# TOP IRON / WOOD BOWS

p 4 of 8  
Rev 2 ✓

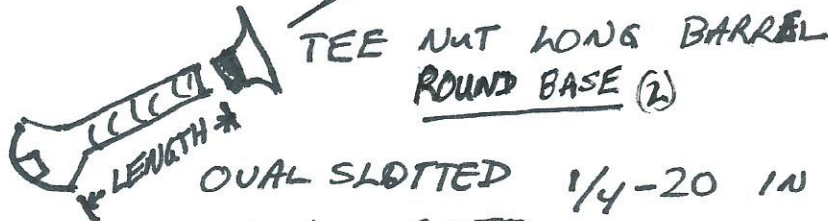
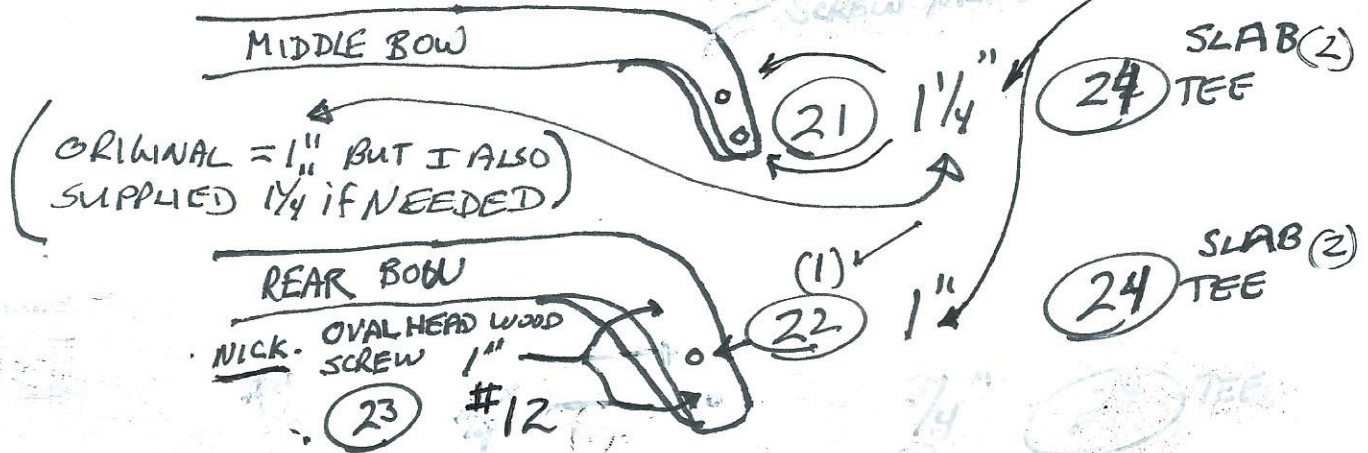
OUVAL SLOTTED 1/4-20 IN all places  
NICKEL PLATED

~~DOVE TAIL~~ is either flat or oval... but majority of people report OVAL. 1" #12 wood supplied as best fit. #12 may a no fit BUT nickel plated \*  
~~discontinued.~~

(1) 1" appears too long & 3/4" may be too short BUT  
7/8" discontinued so 3/4 & 1" both provided.

(2) TWO NAILS USED ON EACH TEE TO INSTALL SMALL NAIL NOT ENCLOSED
